MEMORANDUM

RE: Addendum to the Trillium Woods Apartments Tree Plan for the Protection of Offsite Trees near the Southern Property Line

This is an addendum to the November 19, 2015 tree plan for the Trillium Woods Apartments addressing the protection offsite trees near the southern property line of the project site.

Attachment 1

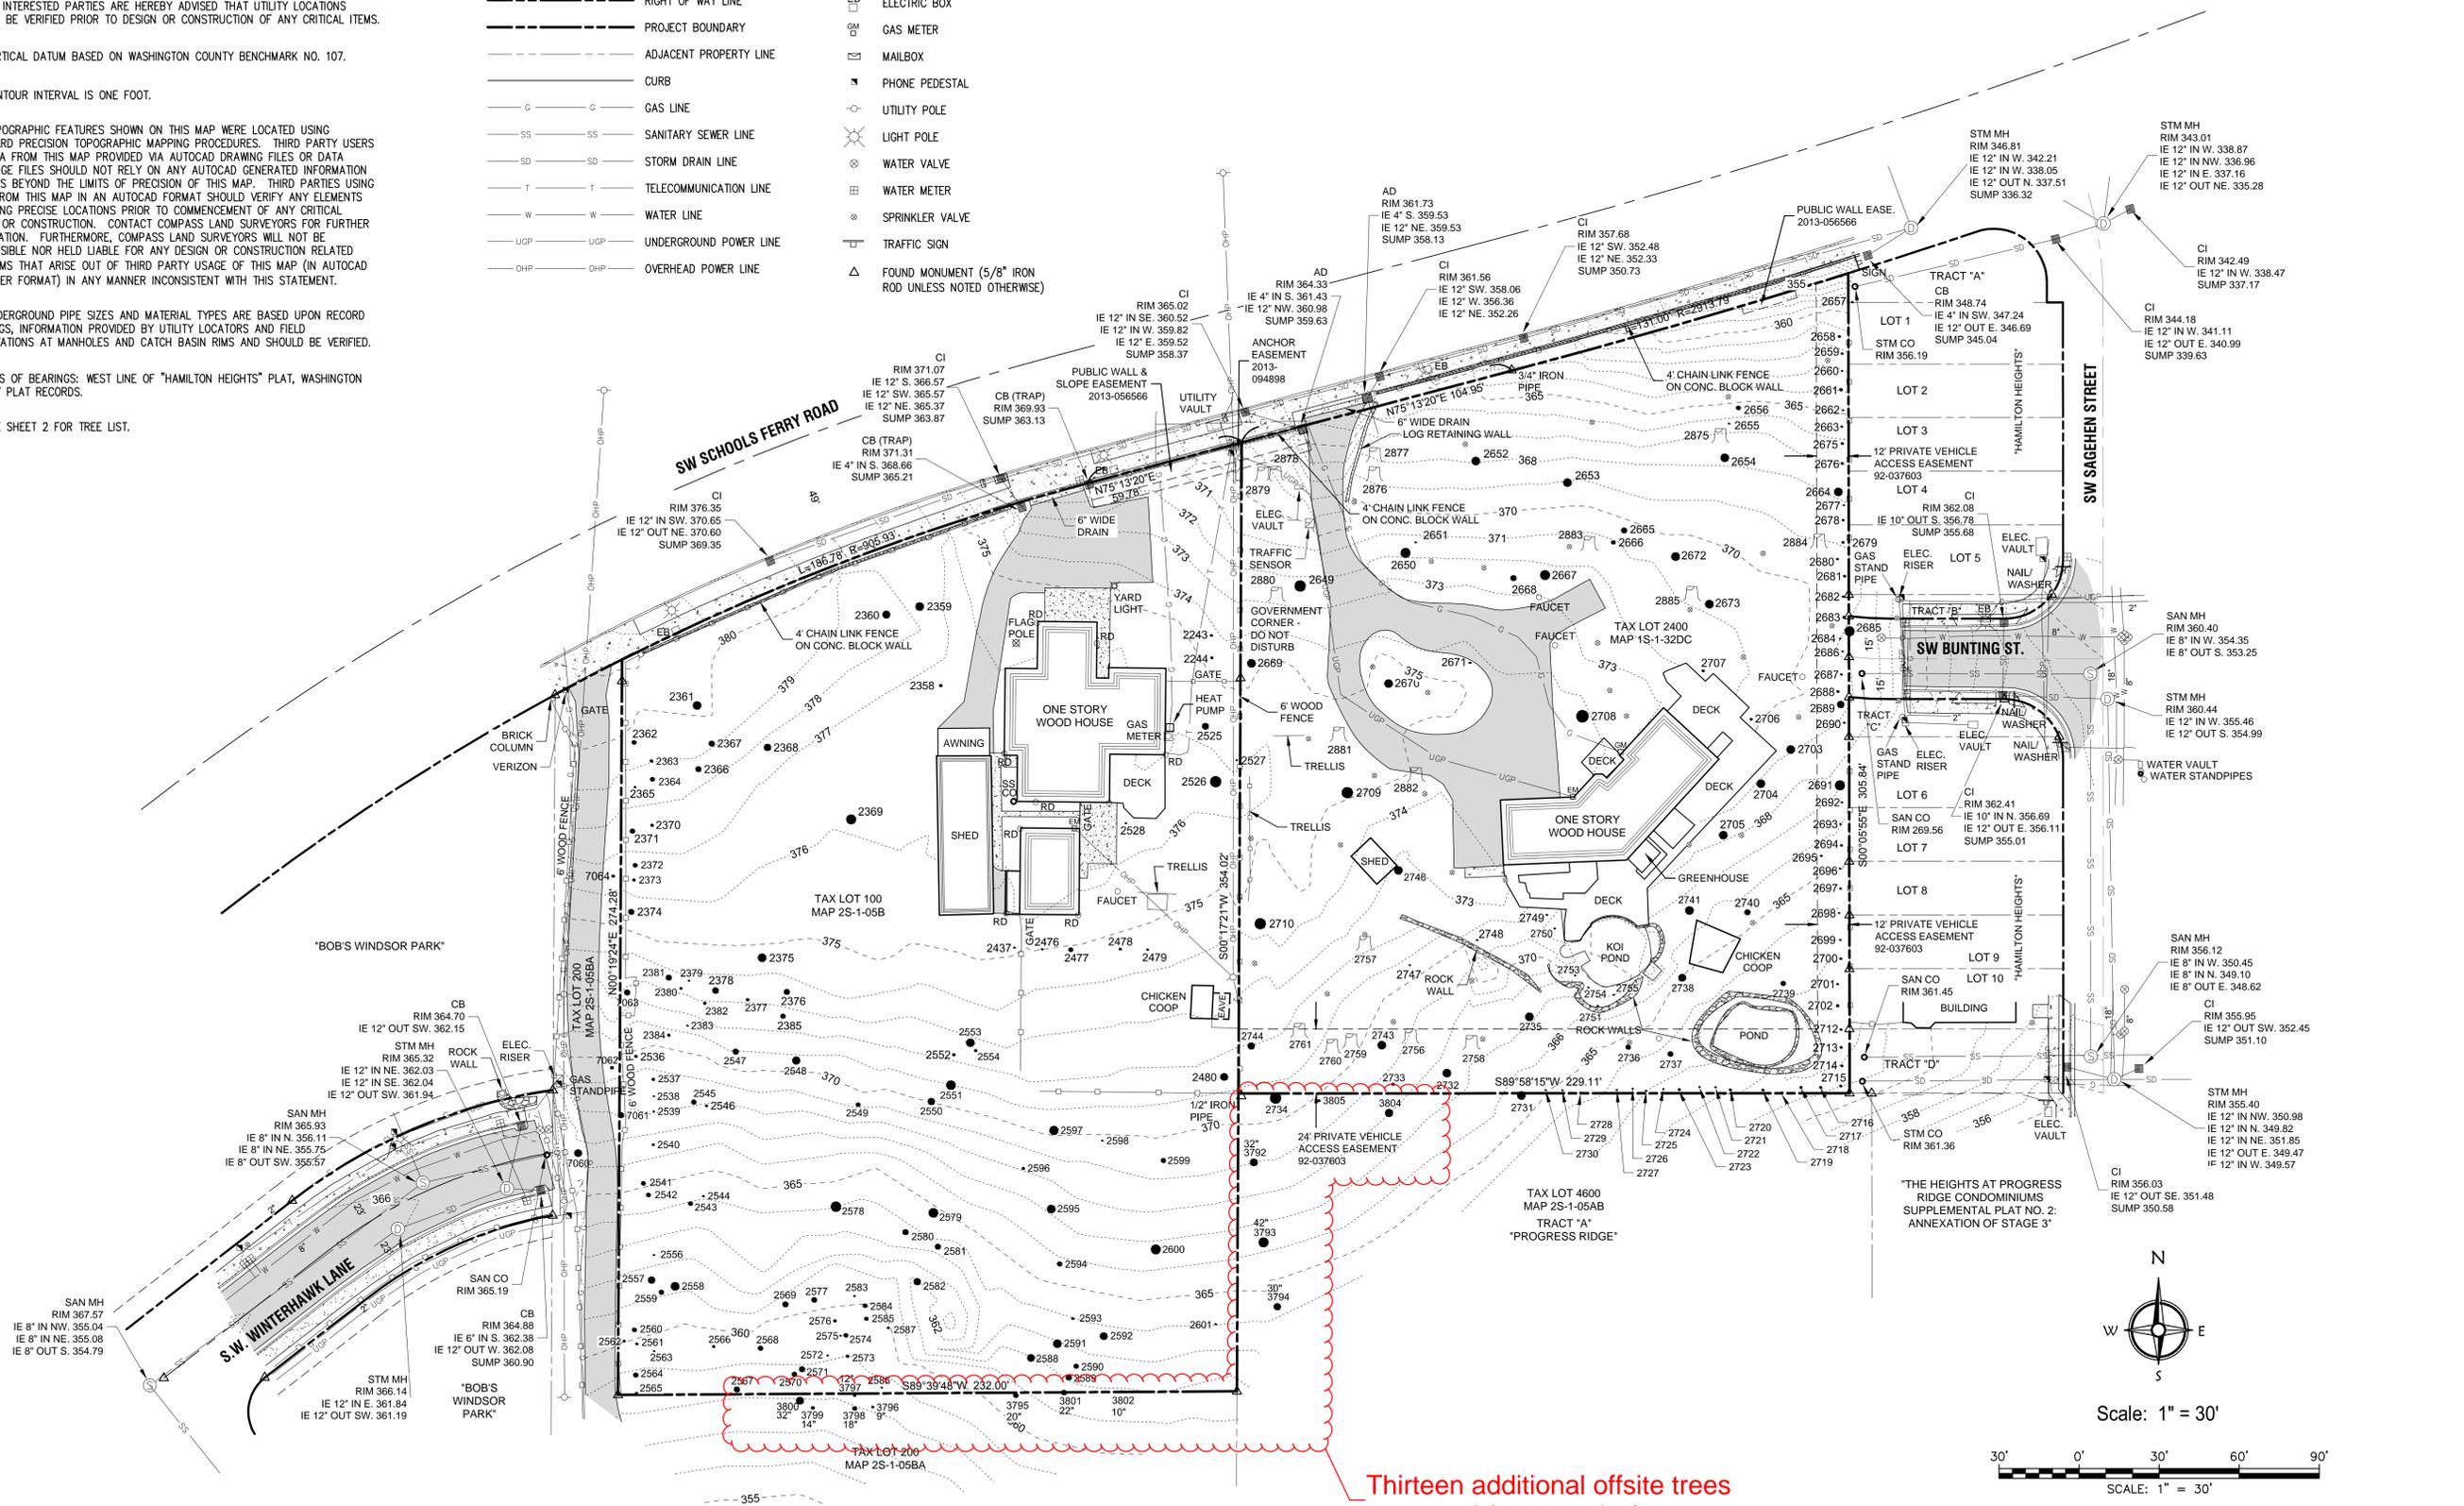
On December 22 and 29, 2015 and January 6, 2016, our firm visited the project site to assess the offsite trees located near the southern property line. A total of 13 trees were assessed and their locations are shown on the updated existing conditions map in Attachment 1.

Thirteen additional offsite trees assessed (3000 series).

SHEET TITLE
TREE PLAN
 SHEET NUMBER
C120

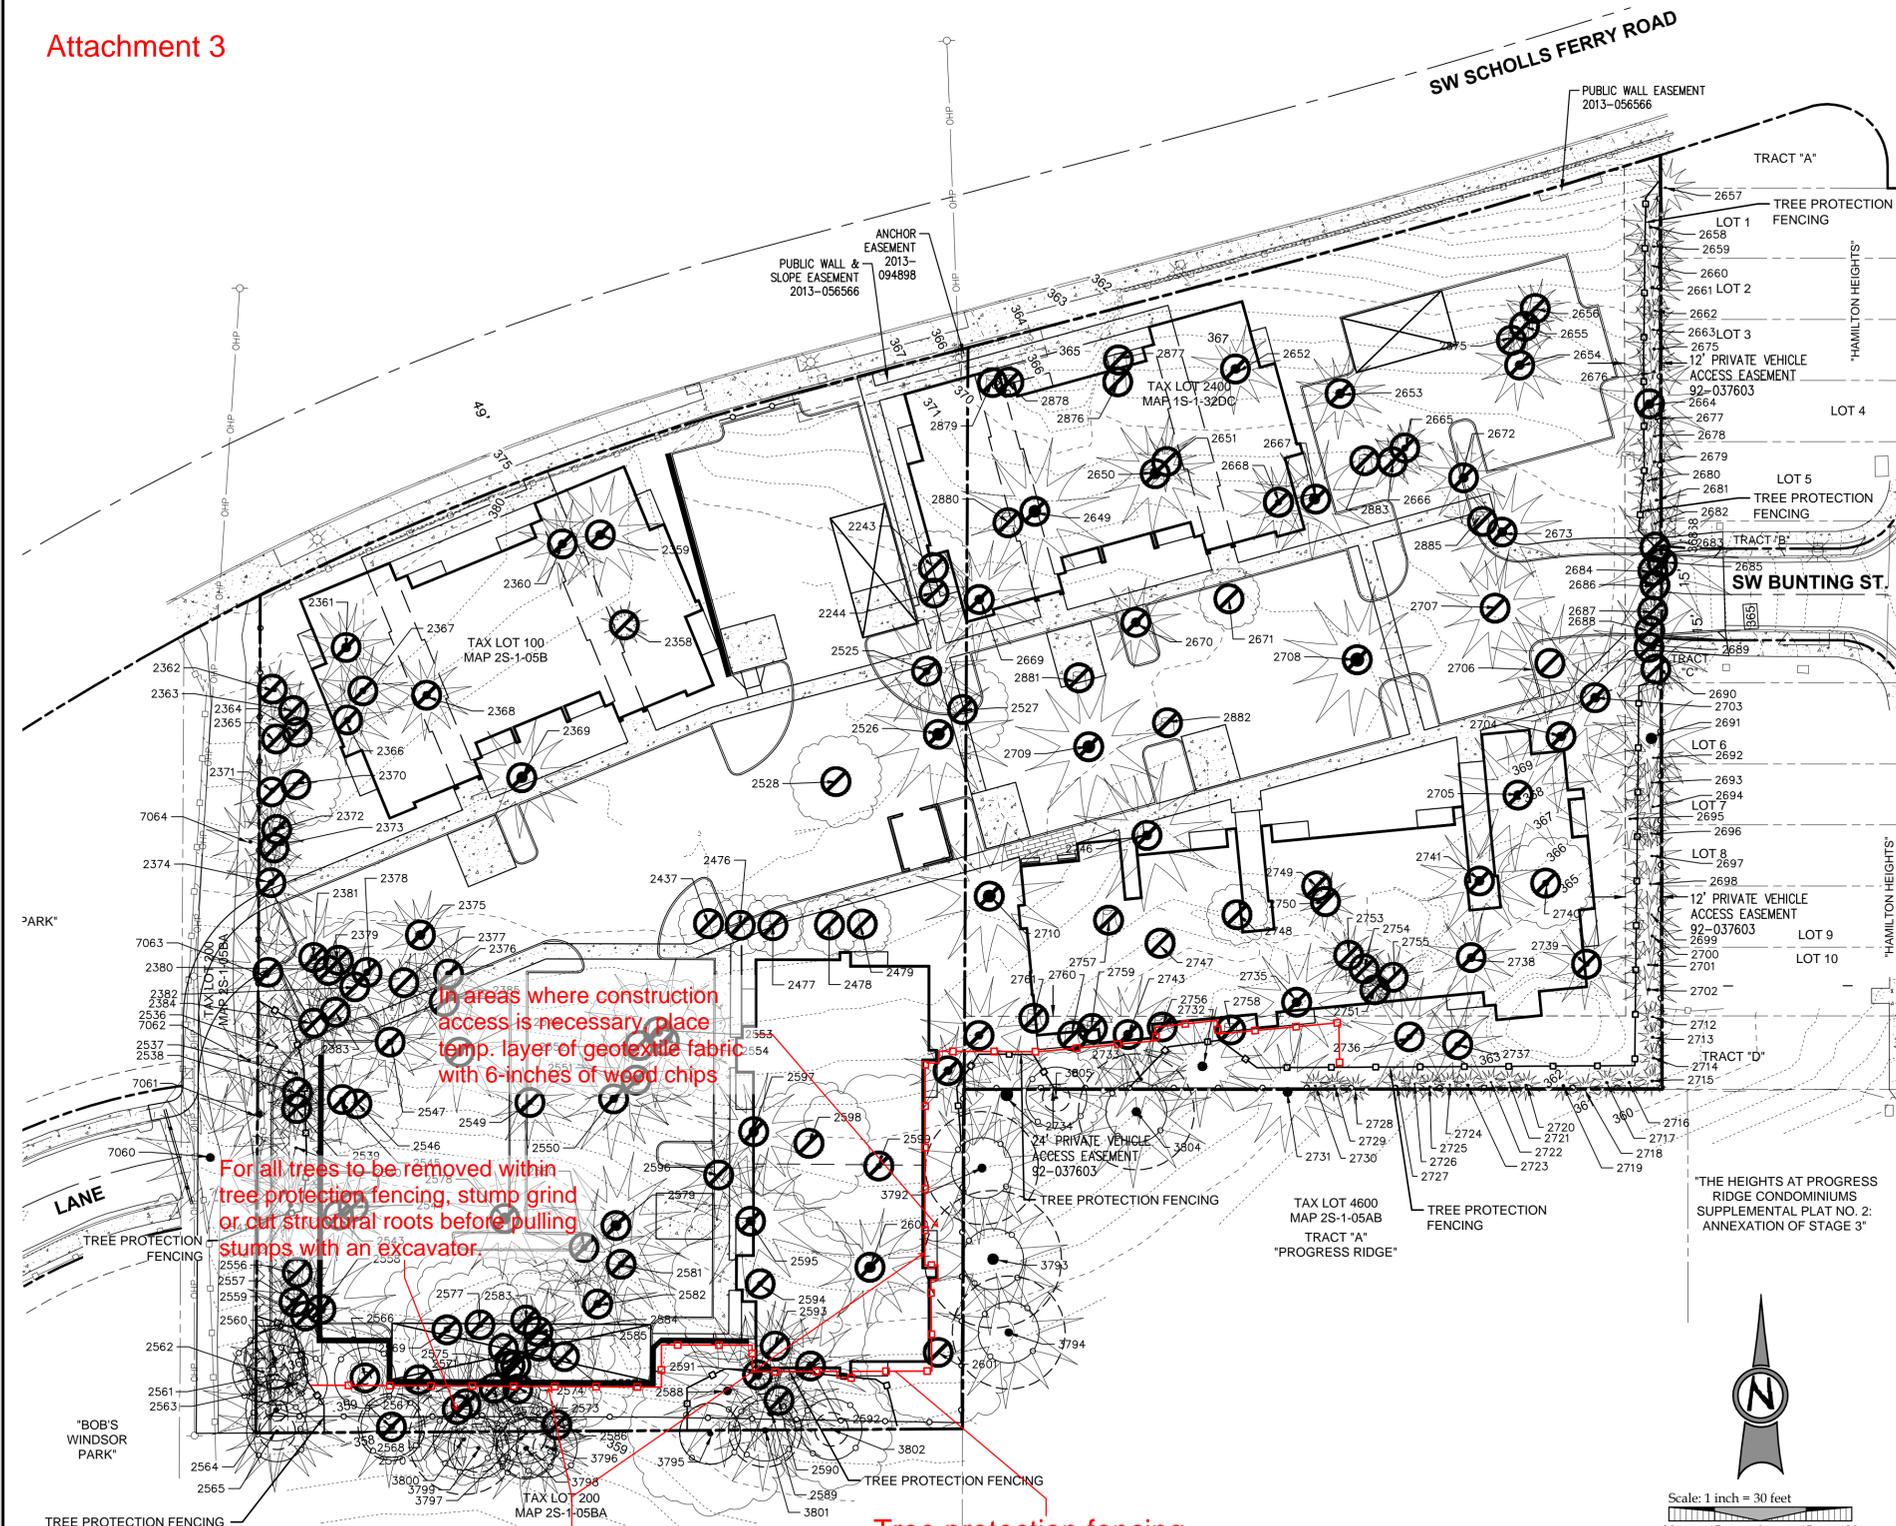
- Any trees to be removed should be fallen away from the trees to be retained so they do no contact, or otherwise damage the trees to be retained.
- The stumps of the trees to be removed that are within the tree protection fencing shown in Attachment 3 should either be stump ground, or have their structural roots cut before pulling with an excavator to protect the root systems of the trees to be retained¹.

- In many cases, the tree protection fencing/zone is immediately adjacent to construction of buildings, retaining wall, etc. Therefore, it is likely that construction access will be necessary within the tree protection zones for work such as siding installation, painting, etc.

In these cases, a six inch layer of wood chips overlaid with geotextile fabric should be placed in the work area to prevent soil compaction. The fabric and woods chips should be immediately removed after construction.

Ensure project arborist is onsite for construction of retaining wall and buildings adjacent to offsite trees.

Tree protection fencing for offsite trees.

In areas where construction access is necessary, place temp. layer of geotextile fabric with 6-inches of wood chips

For all trees to be removed within tree protection fencing, stump grind or cut structural roots before pulling stumps with an excavator.

SHEET TITLE
GRADING PLAN
 SHEET NUMBER

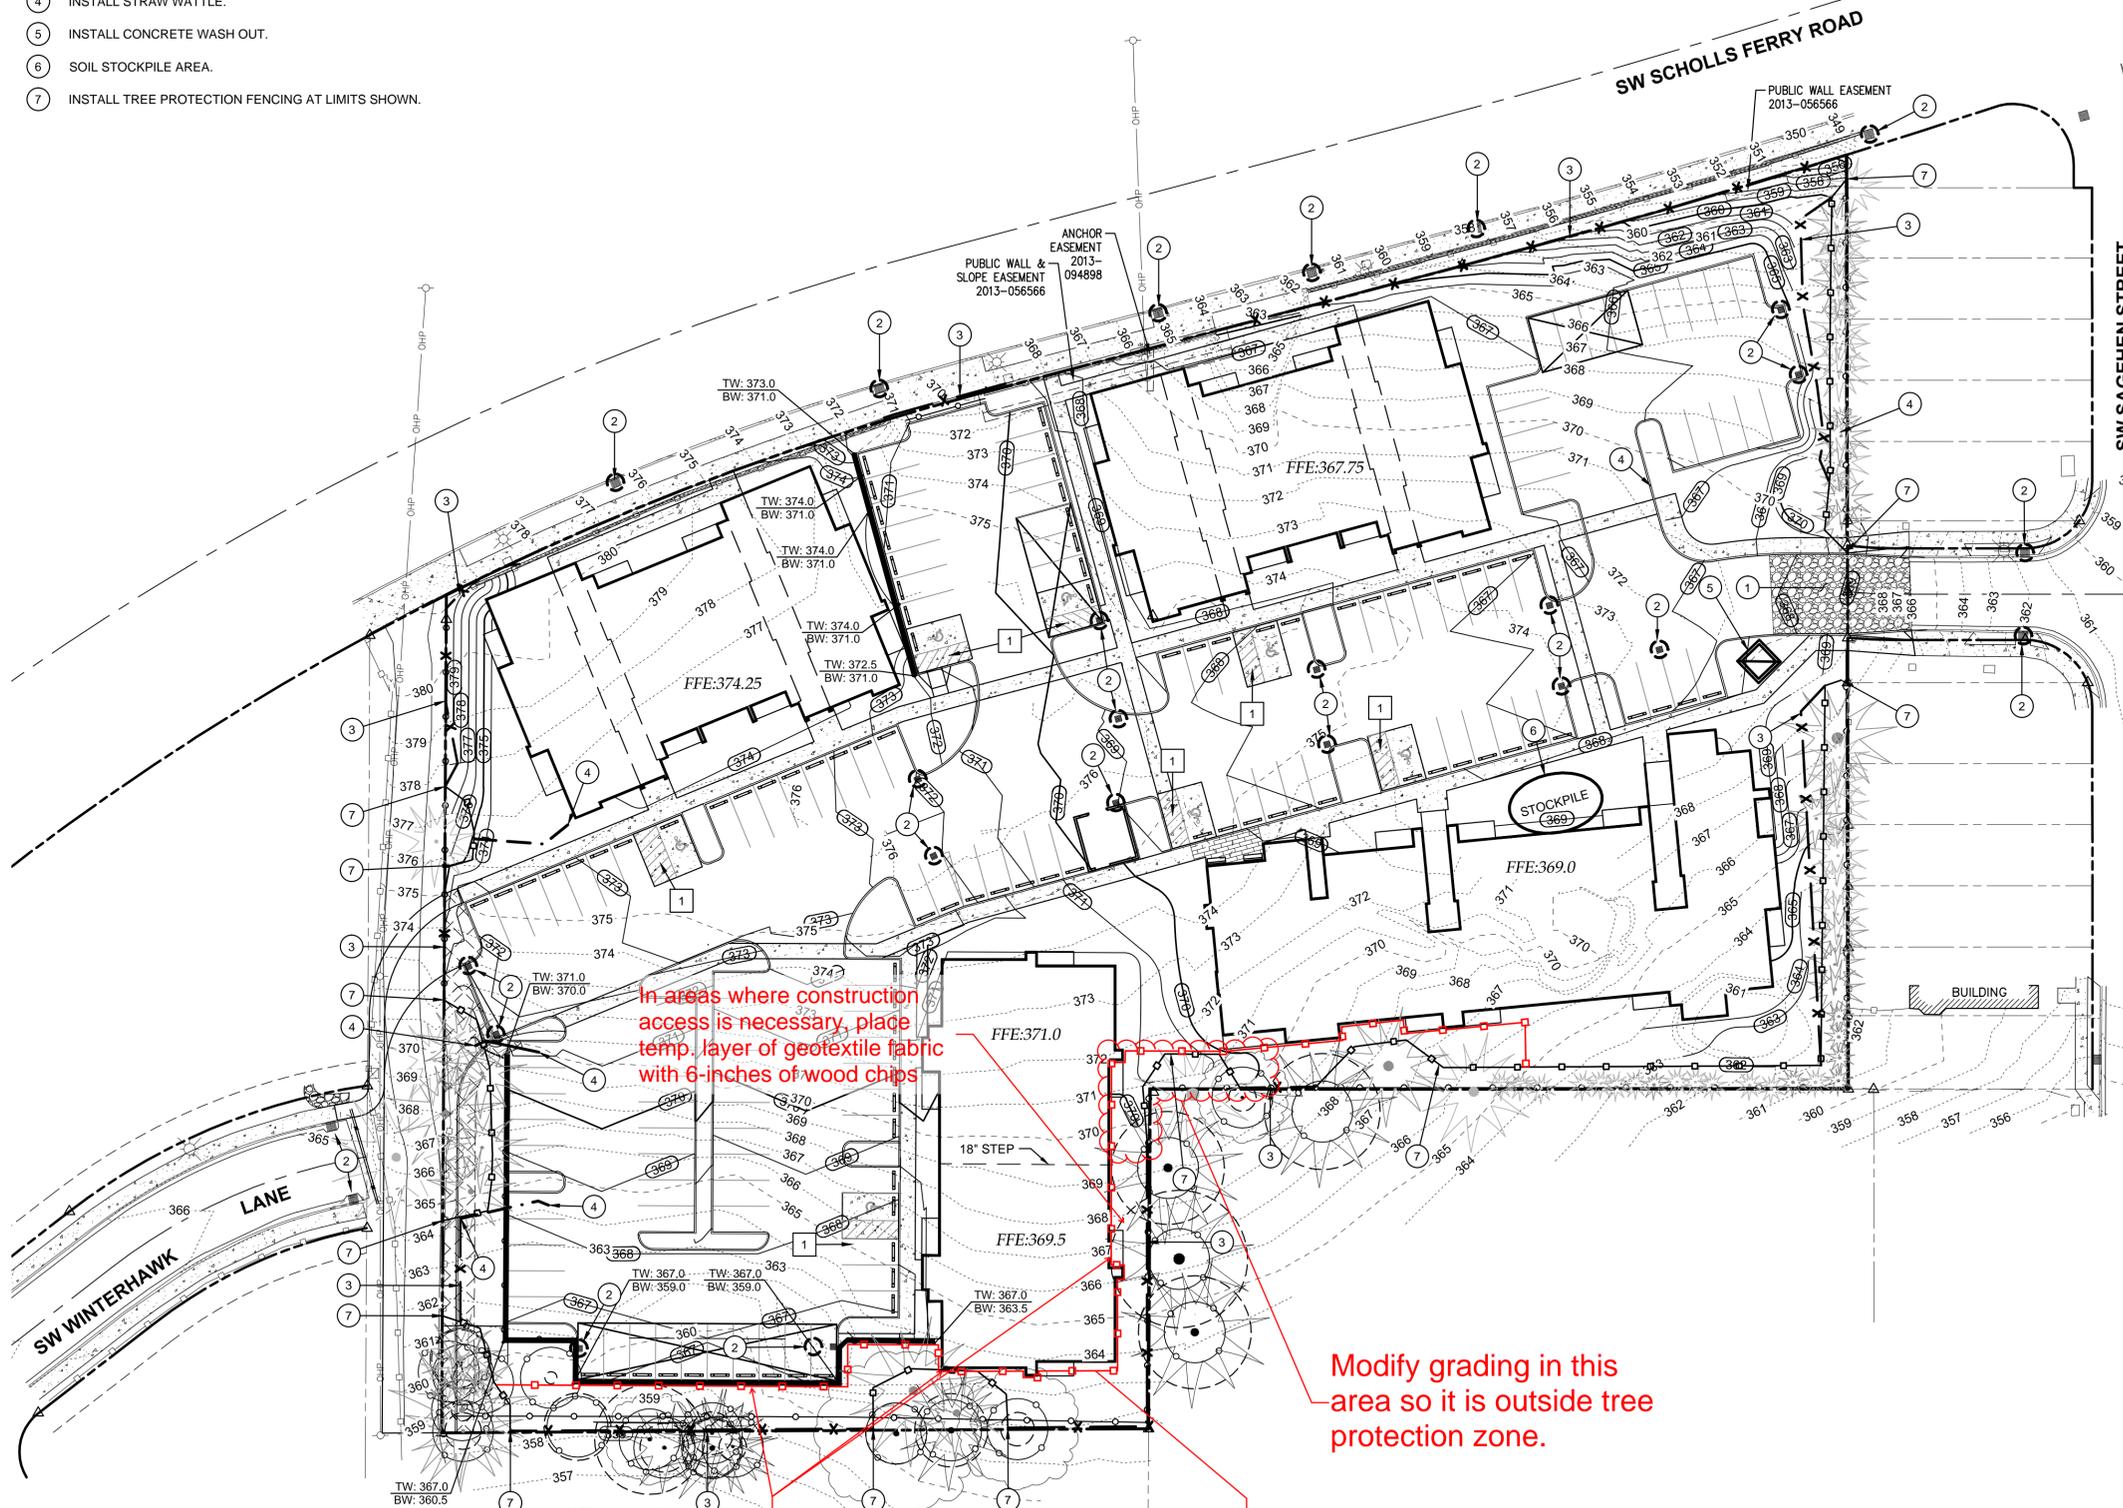
- There is grading shown in the tree protection zone adjacent to trees 2734, 3792, and 3805. The grading should be modified so it is outside the tree protection fencing.

In areas where construction access is necessary, place temp. layer of geotextile fabric with 6-inches of wood chips

Modify grading in this area so it is outside tree protection zone.

Tree protection fencing for offsite trees.

Ensure project arborist is onsite for construction of retaining wall and buildings adjacent to offsite trees.
